Working Party on the Transport of Perishable Foodstuffs

Proposals of amendments to ATP: New proposals

Proposal to amend ATP by introducing special provisions applicable to packages and vehicles and containers containing substances presenting a risk of asphyxiation when used for cooling or conditioning purposes (such as dry ice (UN No. 1845) or refrigerated liquid nitrogen (UN No. 1977) or refrigerated liquid argon (UN No. 1951))

Transmitted by the Government of Switzerland

Figure 6.2

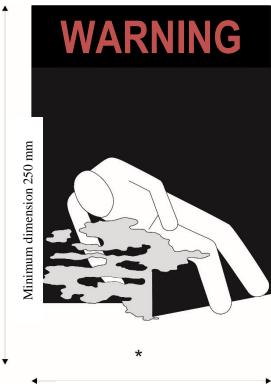
6.2 The warning mark shall be as shown in Figure 6.2.

- * Insert the name indicated in Column (2) of Table A of Chapter 3.2 of ADR/ADN/RID of the coolant/conditioner. The lettering shall be in capitals, all be on one line and shall be at least 25 mm high. If the length of the proper shipping name is too long to fit in the space provided, the lettering may be reduced to the maximum size possible to fit. For example: "CARBON DIOXIDE, SOLID".
- ** Insert "AS COOLANT" or "AS CONDITIONER" as appropriate. The lettering shall be in capitals, all be on one line and shall be at least 25 mm high.

The mark shall be a rectangle. The minimum dimensions shall be 150 mm wide x 250 mm high. The word "WARNING" shall be in red or white and be at least 25 mm high.

Where dimensions are not specified, all features shall be in approximate proportion to those shown.

The word "WARNING" and the words "AS COOLANT" or "AS CONDITIONER", as appropriate, shall be in an official language of the country of origin and also, if that language is not English, French or German, in English, French or German, unless agreements concluded between the countries concerned in the transport operation provide otherwise.
